Part I: Installation of a fixed re-fuelling system in the fuselage
Part II: Return of the wing tank ventilation into the fuselage tank

Subject: Fixed re-fuelling system

Subject: Return of the wing tank ventilation into the fuselage tank

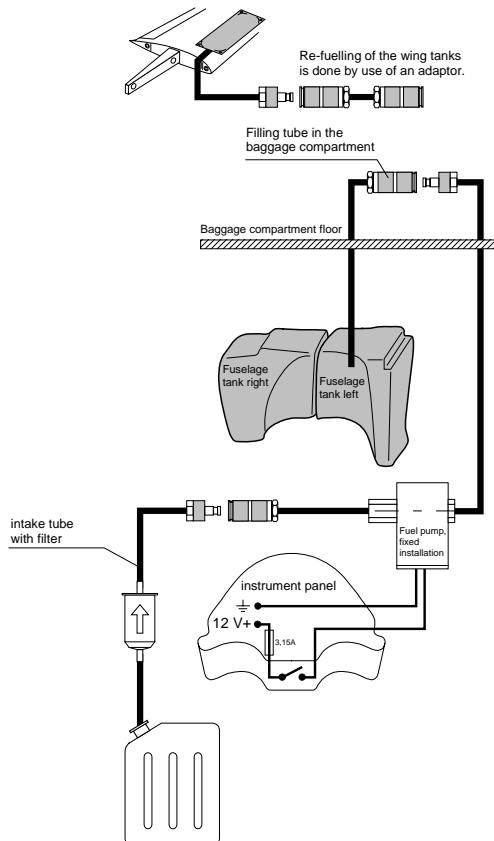
The components of the external re-fuelling system may also be installed fixed in the fuselage; this is offered as an optional extra. Two versions are available:

1. Fuel pump behind barograph box in the fuselage

The fuel pump is located behind the barograph box. The fuel line runs (fire-protected behind the engine bay side wall) forwards to the baggage compartment. Here the re-fuelling system can be connected to the filling tube which is supplied as standard equipment item. The connecting coupling for the external intake tube with filter is located in the barograph box.

2. Fuel pump in front of fire bulkhead

The fuel pump is fitted in front of the fire bulkhead in the area of the control linkage system. The fuel line runs to the baggage compartment. Here the re-fuelling system can be connected to the filling tube which is supplied as standard equipment item. The connecting coupling for the external intake tube with filter is located at the rear shut-off wall of the landing gear compartment; it can be accessed from below through the landing gear box. There is a cover to protect the connecting coupling from dirt; and additionally it is closed by a dust plug.

The fuel pump is actuated via a switch in the instrument panel. Re-fuelling the wing tanks is done by use of an adaptor.

268.62.9006 „Installation re-fuelling system (optional extra)“

Installation of the parts leads to mass changes. In the case of the installation of the pump in the barograph box also the influence on the C.G. range must be taken into account.

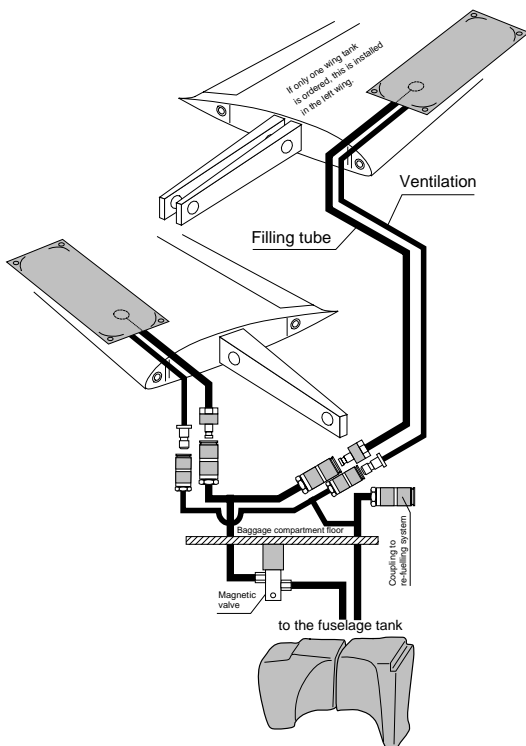
If during re-fuelling the wing tanks are overfilled inadvertently, fuel could escape via the ventilation at the end rib of the inner wing, fuel which better should be collected for environmental reasons. In order to avoid such the vent tube can be returned into the fuselage tank. This tube however requires a separation joint at the fuselage to wing intersection; a separation joint which **must** be connected additionally during each rigging. The couplings used at this point are different from the existing wing tank couplings to exclude a mix-up.

Material and Drawings:: 268.62.9005 „Wing tank ventilation, return into the fuselage tank “

Mass & C.G.: After the installation of these parts the change in mass is low and, therefore, the influence on empty mass and C.G. is negligible.
